ADDENDUM NO. B

Colton MS Administration Modernization & New Locker Room Building – DSA App #04-123792)

Colton MS Pavillion – DSA App #04-123039

Colton Joint Unified School District
1212 Valencia Drive
Colton, CA 92324

ADMIN BLDG
DEMO & MOD CEILING PLANS

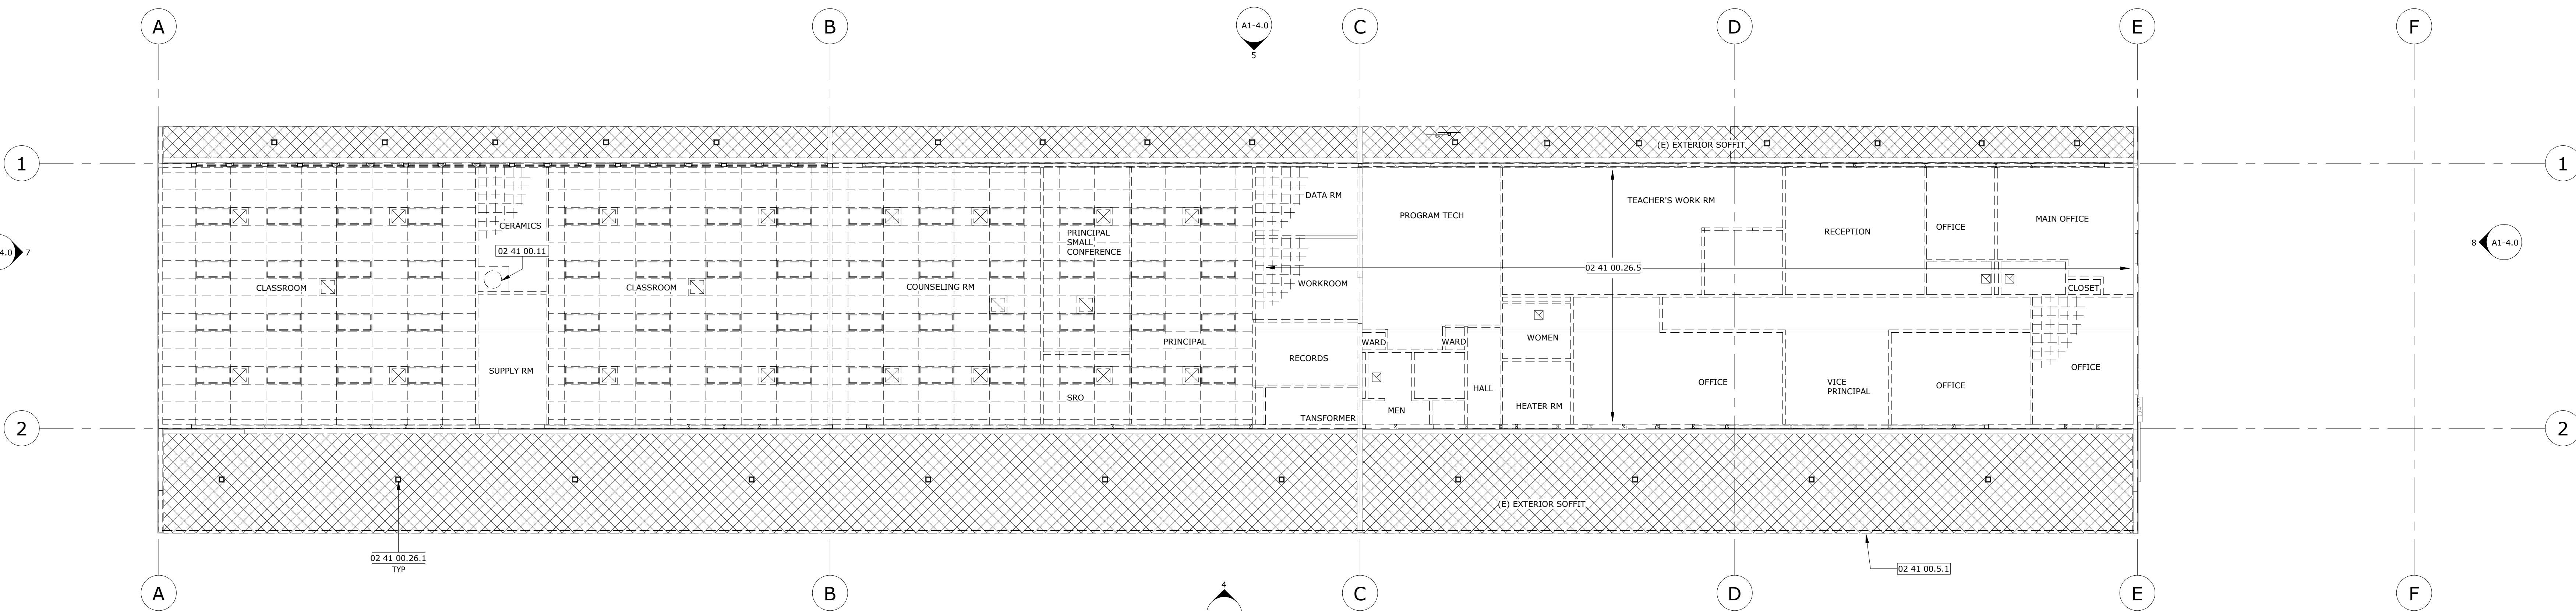
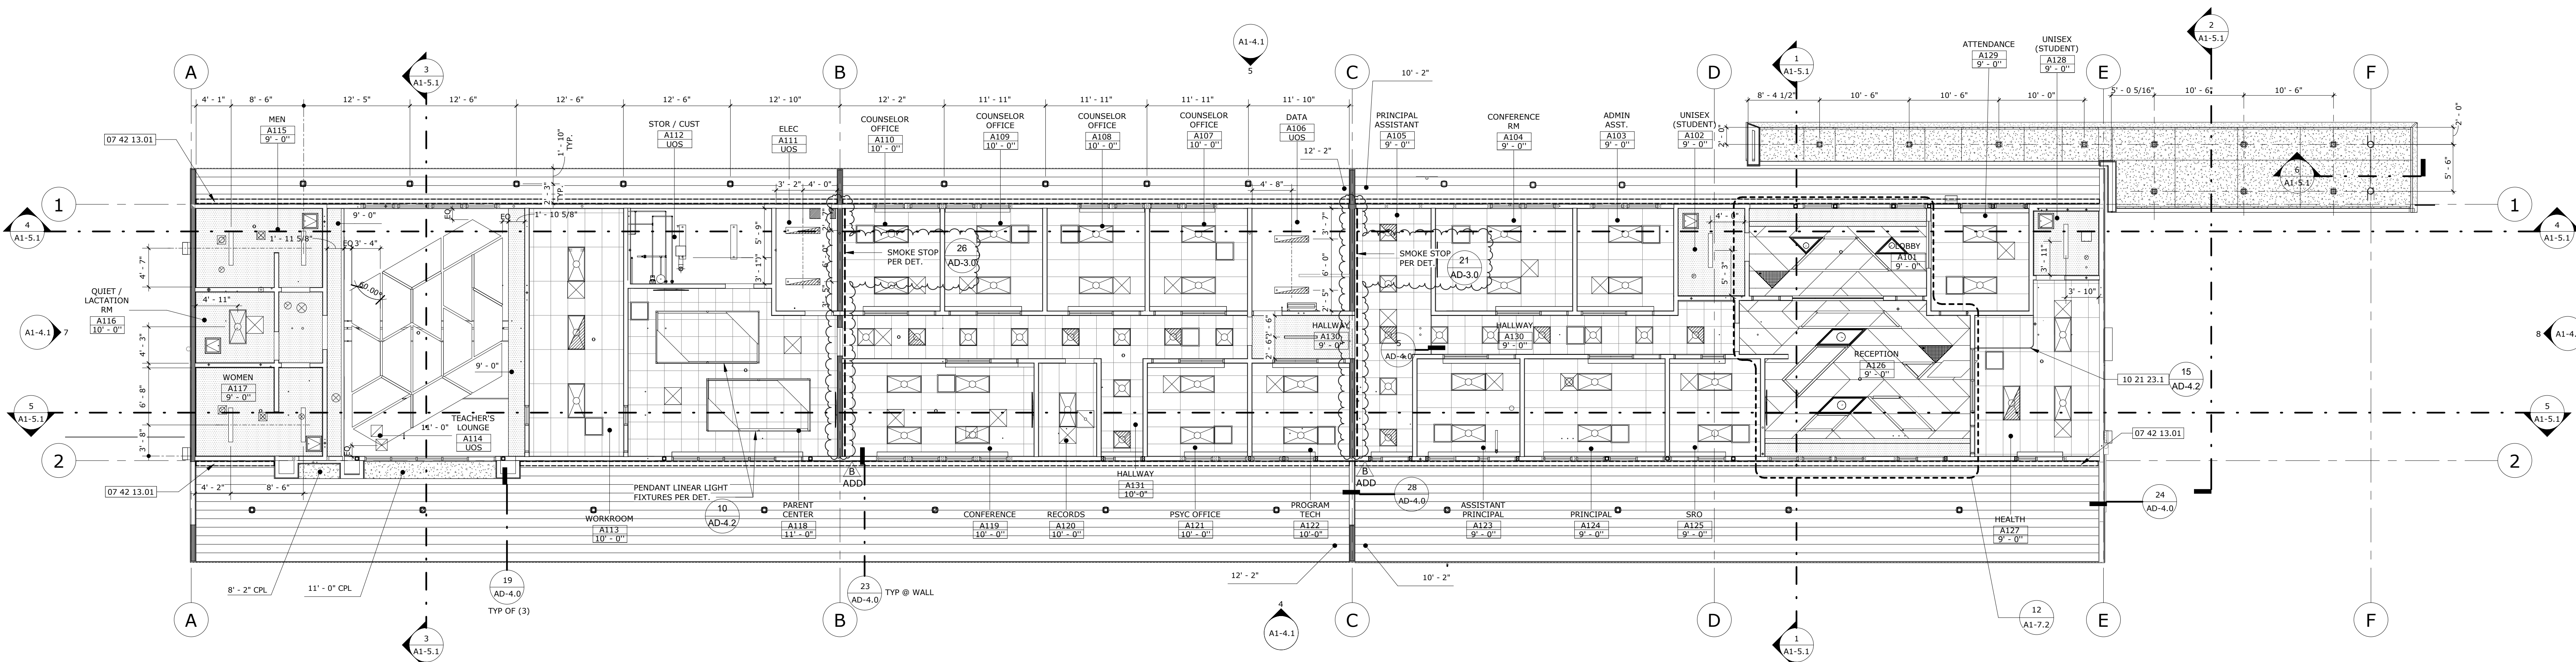
- Item No. B.20 Reference Sheet A1-2.0 – Admin Bldg Demo & Mod Ceiling Plan:
- B.20.1 Added smoke stop notes on Detail 2 per clouded areas.

EAST-WEST SECTION	SCALE: 1/8" = 1'-0"	5
-------------------	------------------------	---

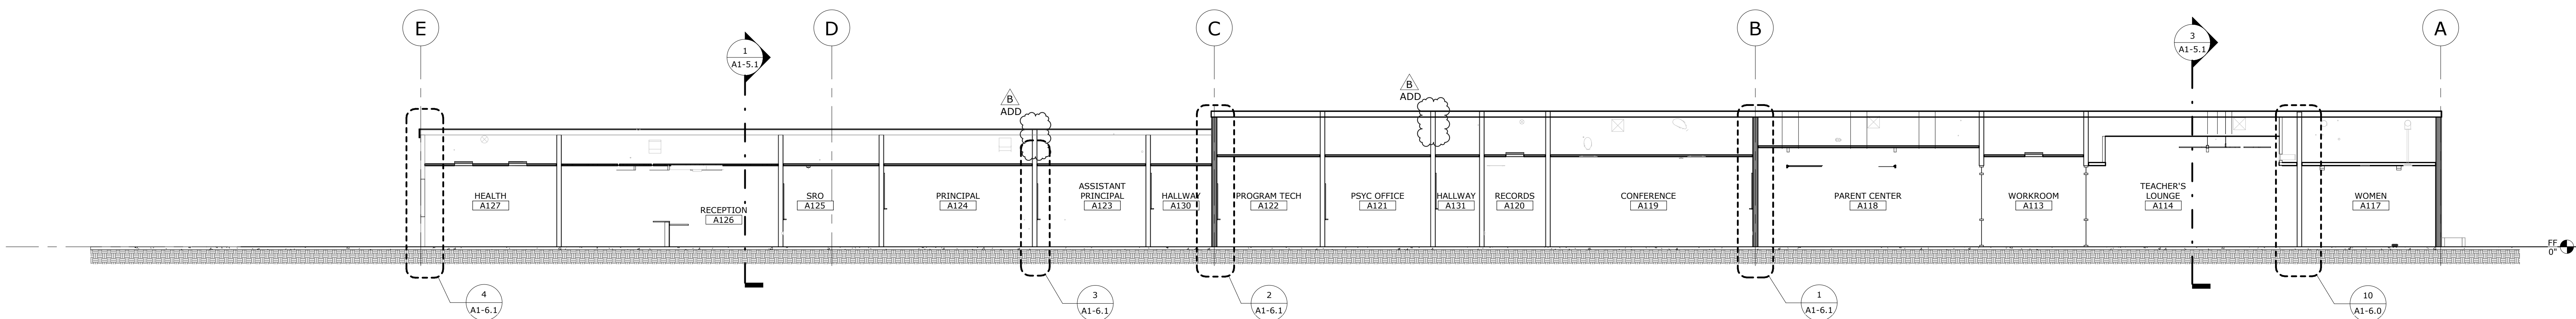
- Item No. B.21 Reference Sheet A1-5.1 – Building Sections:
- B.21.1 Extended walls to roof structure on Detail 5 per clouded areas.

WALL SECTION SCALE: 1/2" = 1'-0" 3

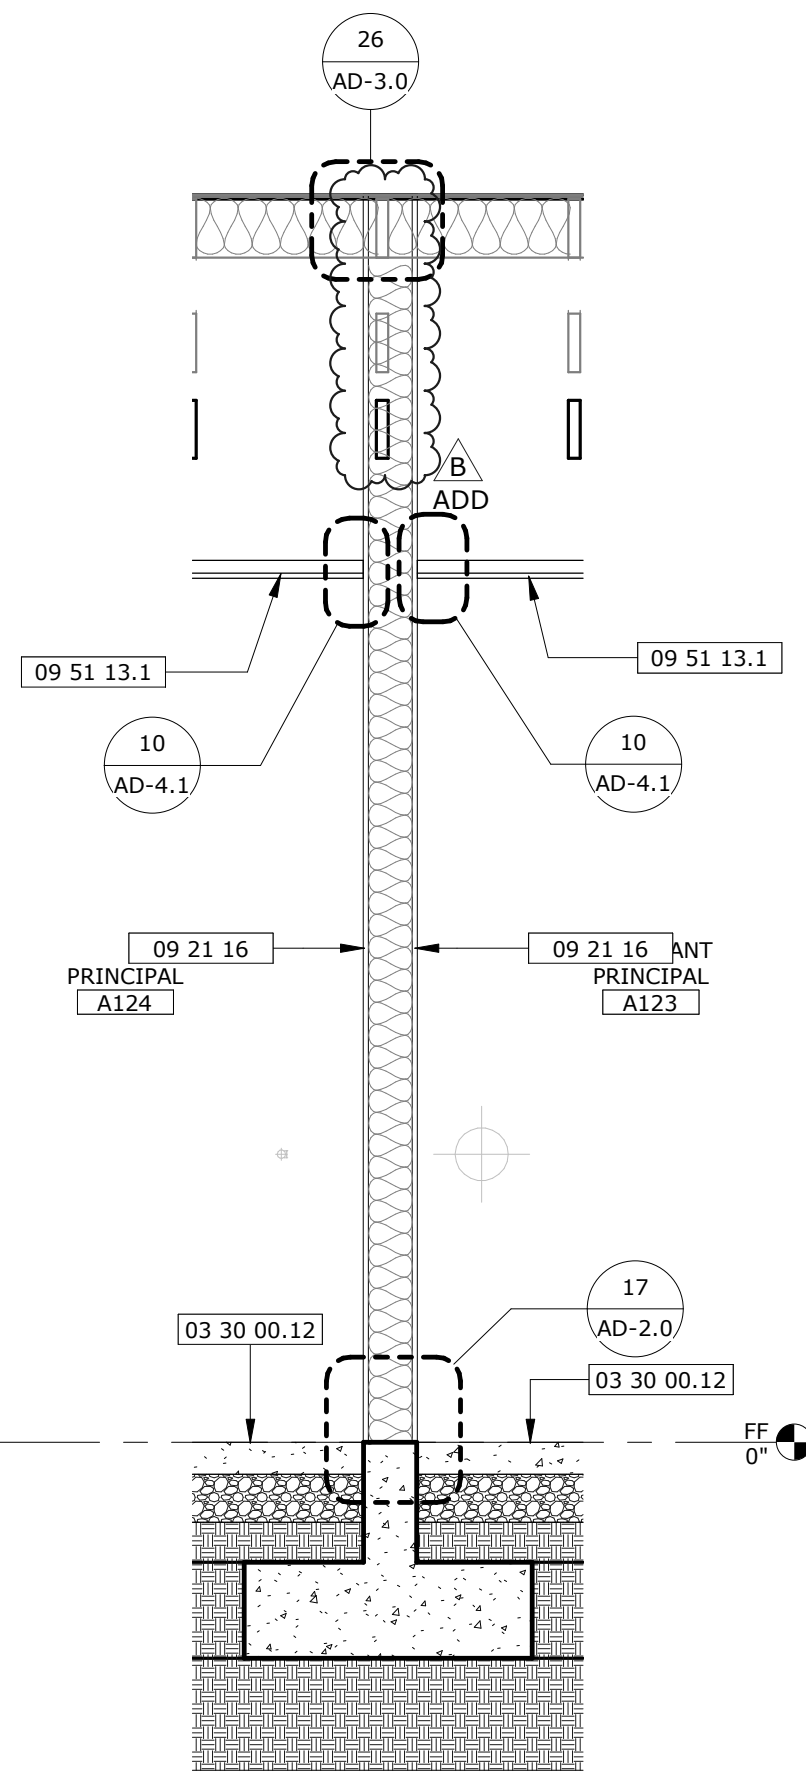
- Item No. B.22 Reference Sheet A1-6.1 – Wall Sections:
- B.22.1 Extended walls to roof structure on Detail 3 per clouded areas.
